Idaho National Engineering Laboratory

TECHNICAL REPORT

EVALUATION OF EPRI DRAFT REPORT NP-7065 - REVIEW OF NRC/INEL GATE VALVE TEST PROGRAM

Prepared for the
U.S. NUCLEAR REGULATORY COMMISSION

Figure 16. Stem force for Valve 2 during Step 25 of Test 1.

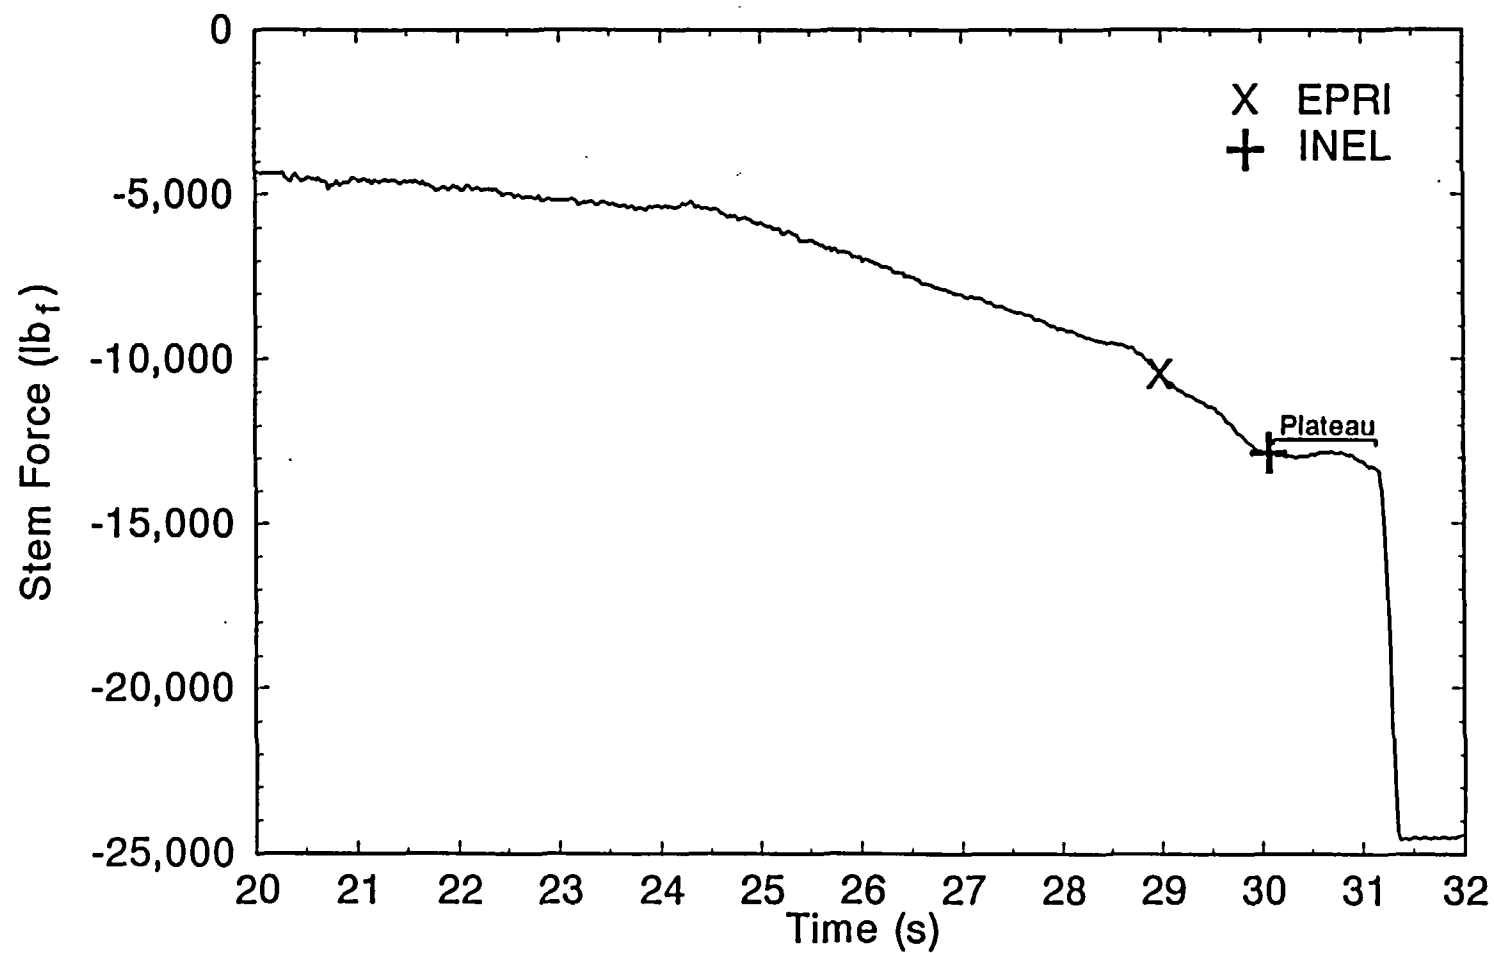
. By way of example, Figures 16 through 18 show the stem force, the upstream, bonnet, and under-the-disc pressure, and the downstream dynamic pressure histories for Valve 2 Test 1 Step 25. Also shown on each of these figures is the point identified as flow isolation as shown on Table 6-1 of the EPRI report and the point used by the INEL to assess the response of the valve.

While it is true that downstream dynamic pressure is a better indication of flow isolation than downstream static pressure, we have found the plateau on the stem force trace (Figure 16) to be the best indicator of flow isolation, as confirmed by the convergence of the three valve pressures and by the decay of the downstream dynamic pressure. For predictable valves, this plateau represents the maximum force before wedging. The point identified in the EPRI report as flow isolation typically lies before this plateau rather than on it, thus yielding too low a value for the stem force necessary to achieve true flow isolation.

Figure 25. Flow meter differential pressure trace for Test 2 of Valve A, Phase I.

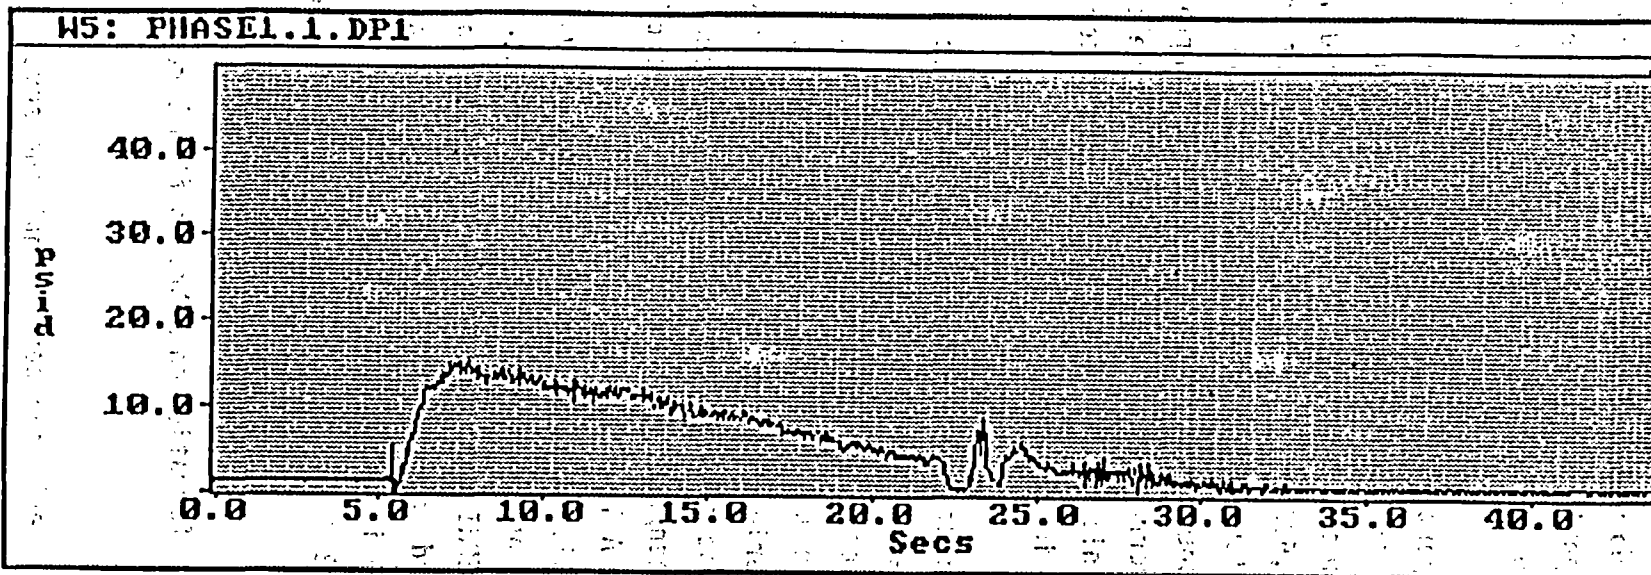
The EPRI report identifies other tests where *"some nitrogen may have been passed through the blowdown pipe and test valve during the stroke without a complete transition from water to nitrogen occurring."* One of these tests is Test 2 for Valve A. Figures 25 and 26 show pressure traces for the Phase I Test 2 first blowdown stroke (compare with Figures 23 and 24). Figure 25 shows the flow meter differential pressure for this test and indicates a large disturbance at about 23.5 seconds. The EPRI report identifies this as an indication that nitrogen-entrained water was flowing. However, the other pressure traces, shown in Figure 26, show a different response than was observed during Test 3 Step 5. During Test 2, the valve upstream pressure, the downstream pressure, the exit pressure, and the valve differential pressure all decrease at the time of the flow meter disturbance. This indicates a drop in pressure throughout the system, consistent with water flashing to steam upstream of the

Fluid volume calculations also support this conclusion. During Test 2, the maximum flow (7,500 gpm) was measured at 15 psid (Figure 25), and the flow decreases somewhat linearly to zero 26 seconds later. The total consumed water inventory for Test 2 was approximately 1,625 gal, slightly less than half of the total accumulator inventory. The water level in the accumulator was over 8 feet at the end of the test. Flow rate was about 2000 gpm when the disruptionpointed out in the EPRI report occurred. This corresponds to an in-tank fluid velocity of about 0.09 ft per second. It is unlikely that nitrogen would enter the discharge with the water over 8 ft deep in the tank.

PRESSURE, DP, AND POSITION HISTORIES
FOR BLOWDOWN CLOSING TEST
FIGURE 2-2

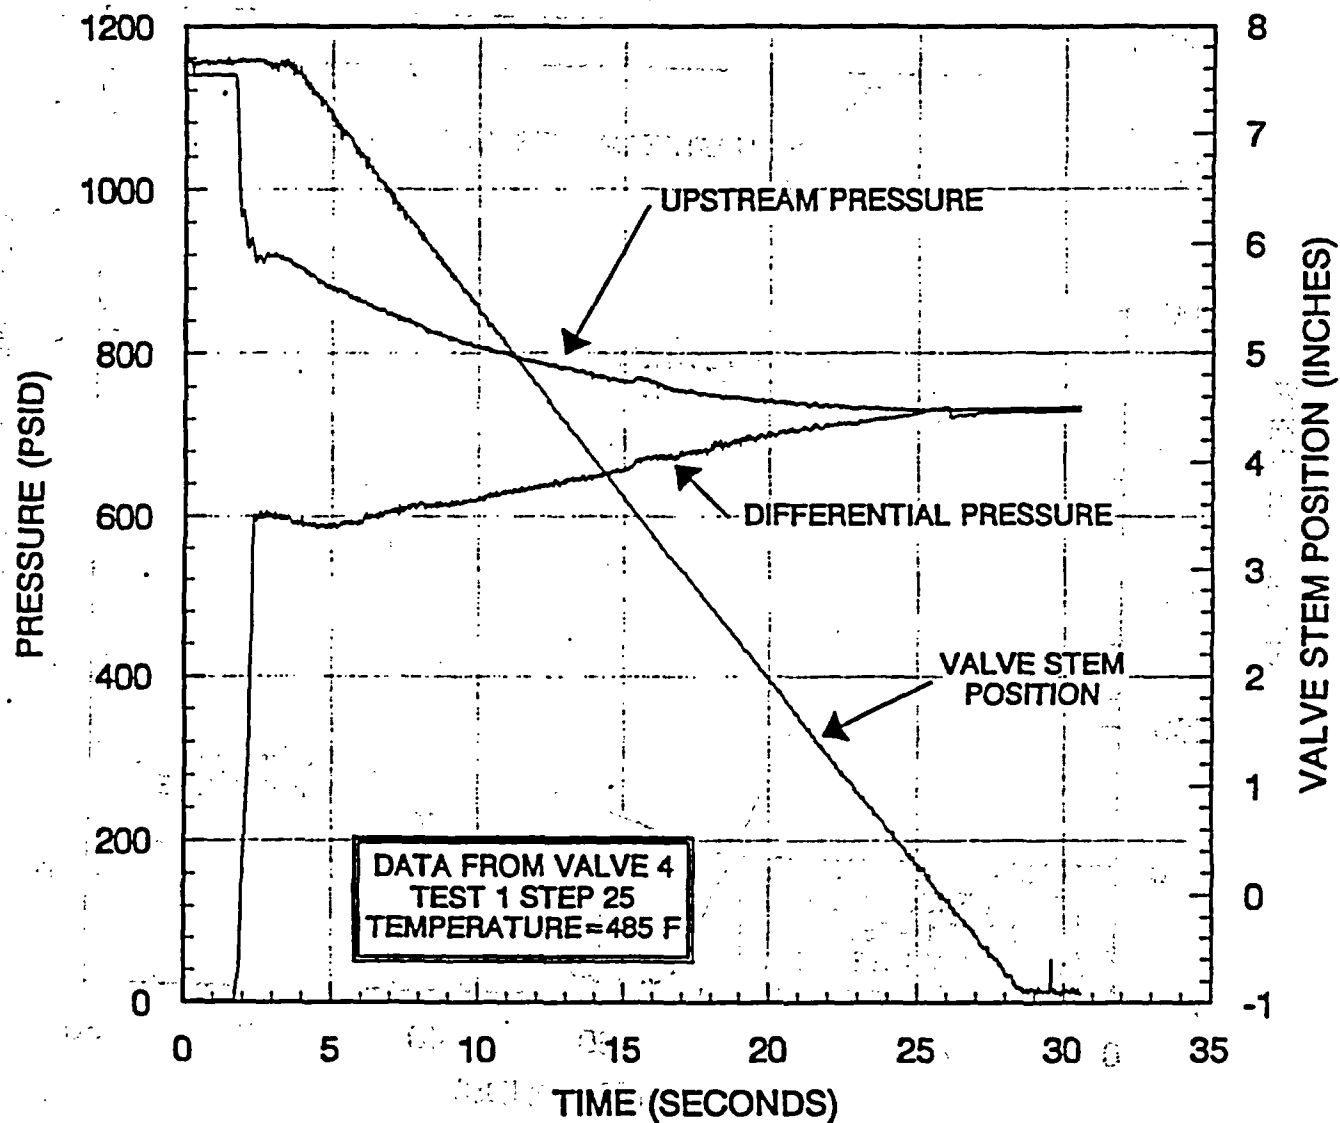
In blowdown tests (Figure 2-2), upstream pressure drops with flow and may not fully recover to its pretest value, even at closure. With the upstream, bonnet, and under disc pressure changing independently, the normalized DP is not proportional to disc forces. Packing drag and stem rejection forces are once again not represented, although they are less significant in blowdown tests. The actual ratio of DP to upstream pressure can be affected by many conditions, including upstream pressure, flow rate, flow medium (water or steam), flow restriction (upstream or downstream of the valve), subcooling (with the possibility of flashing), direction of valve actuation (opening or closing), and rate of valve actuation. Comparisons of such ratios, such as those shown in EPRI's Figures 2-5 through 2-7, are not useful indicators of DP behavior unless it is known that all those conditions are the same for the tests being compared. Even then, it is unlikely that such ratios will provide the analyst any useful information.

NORMALIZED DP VS. STROKE FOR BLOWDOWN
TESTS AND VALVE IN PUMPED SYSTEM
FIGURE 2-7

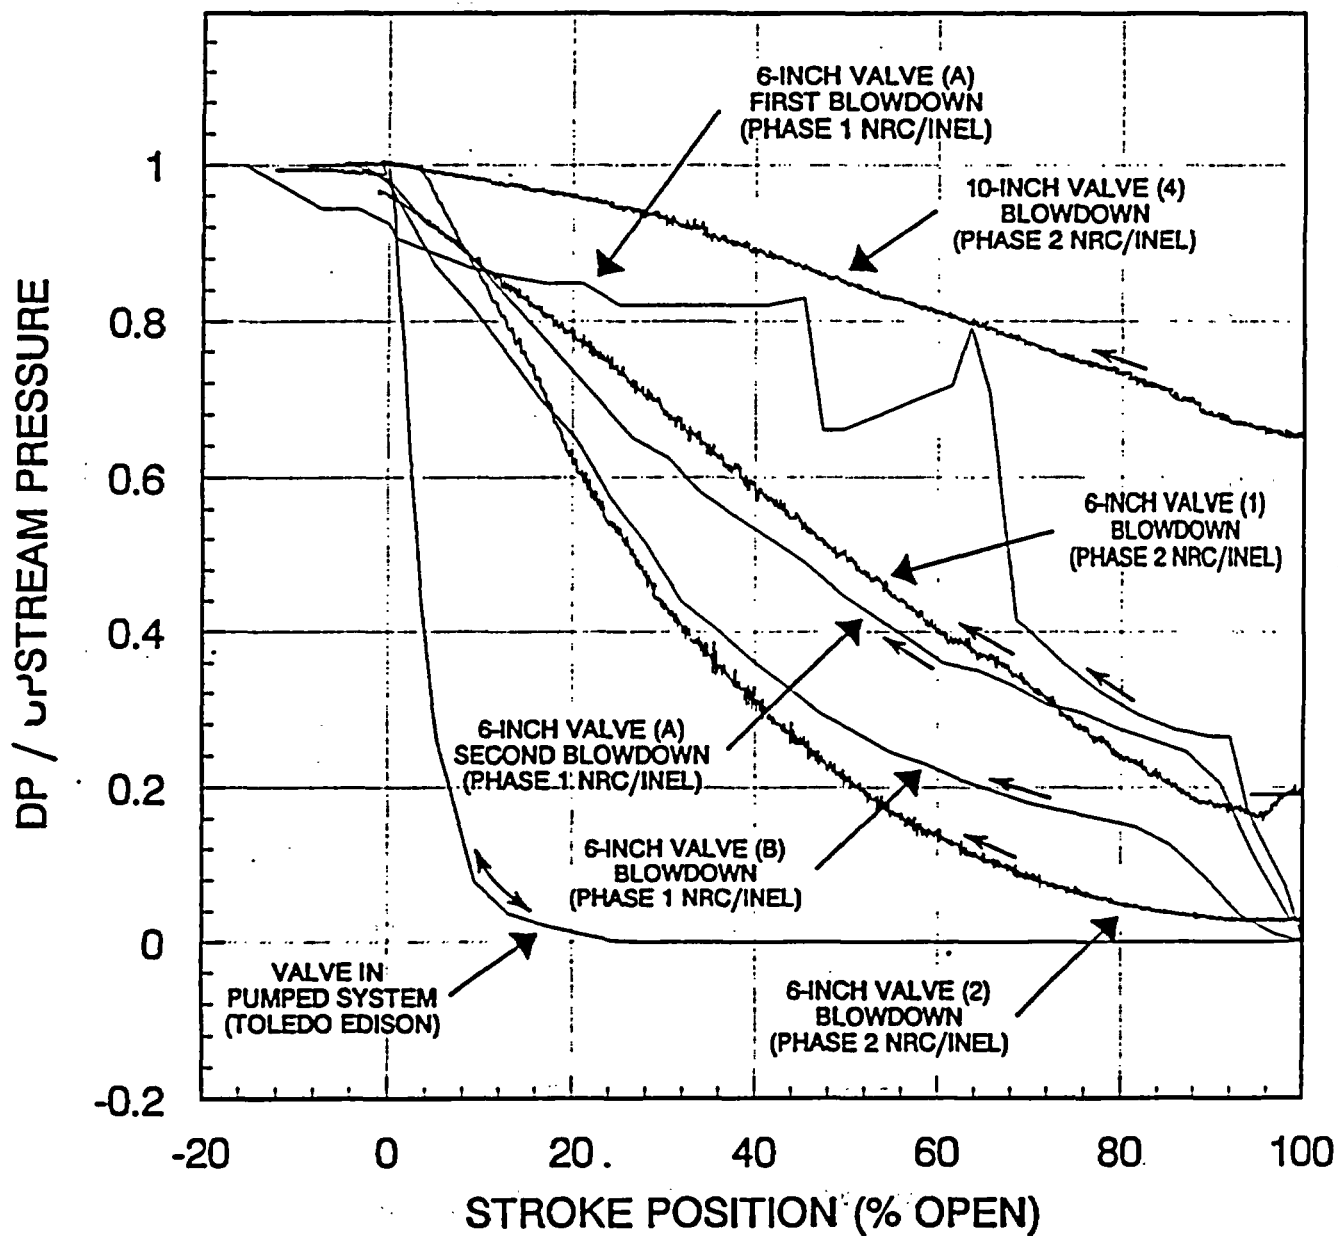
Figure 2-7 shows normalized DP vs. stroke behavior for blowdowns of four

3. Blowdown conditions for 6-inch valves, even when tested in the same loop, showed considerable differences. For example, Valves 1 and 2 showed significantly different behavior during mid-stroke (Figure 2-7). Although some of this behavior may be attributable to valve flow resistance differences, it appears more likely there were differences in the way the test facility operated. Valve 3, although not shown, started off with a DP

Figure 2-7 in the EPRI report actually shows that without a significant loss in upstream pressure, Valves 1 (A) and 2 (B) show different but very reproducible behavior between Phases I and II. Note how the Valve 1 and A traces lie almost on top of one another. The same is true for Valve 2 and B. Recall that Phase I and II used different test facilities with completely different piping configurations. The EPRI report's argument for a difference in how the facilities operated as the cause of the

FLOWMETER DP, VALVE DP AND STEM FORCE
FOR FIRST VALVE A BLOWDOWN CLOSING STROKE

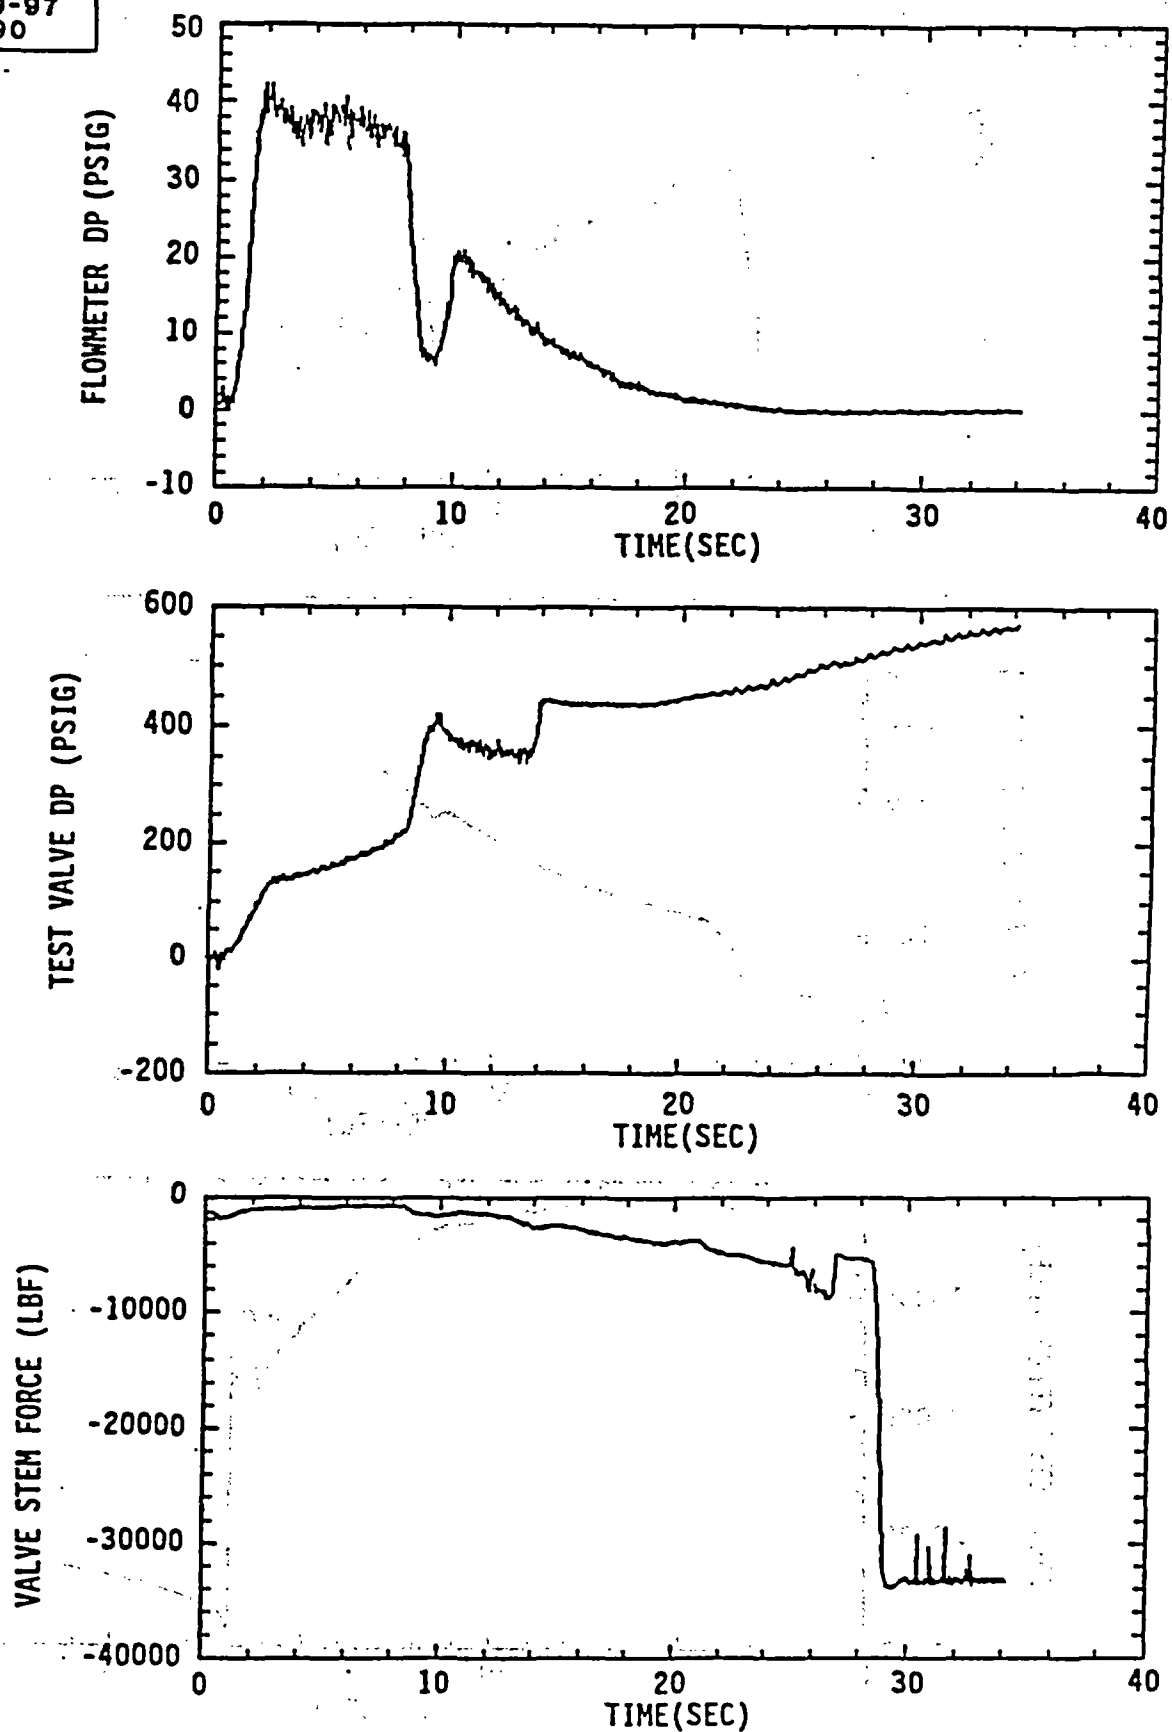
A complete transition from water to nitrogen flow appeared to occur on the first blowdown stroke of Valve A (Test 3 Step 5). Figure 2-8 shows the DP across the upstream flowmeter and across the test valve. At a time of about 8 seconds, the flowmeter DP drops sharply. After about one second, it rises again. If a water/nitrogen interface passed through the system, the flowmeter at the upstream end of the system would first show a sharp drop as the fluid density dropped. Then, as the water slug in the system was accelerated and ejected from the system, the DP would increase, first gradually (during acceleration) and then sharply (at ejection). This behavior is seen on the flowmeter DP plot in Figure 2-8. At the test valve location, which is further downstream, DP would be expected to increase as the water slug was accelerated, drop as the nitrogen arrived at the valve and then increase as the slug cleared. This is consistent with the observed behavior, although the times are not as sharply defined. This could be due to a blending of nitrogen and water as it flowed downstream. Nonetheless, it appears that after about 10 to 14 seconds, when the valve was about 30-45% closed, only nitrogen was flowing through the valve. The valve stem force plot, also shown in Figure 2-8, shows that substantial forces developed only in the last one-half of the valve stroke, i.e., when nitrogen flow was occurring.

also that there is nothing in the EPRI reports' Figure 2-8 to indicate that nitrogen entrainment had any effect on the measured stem force.
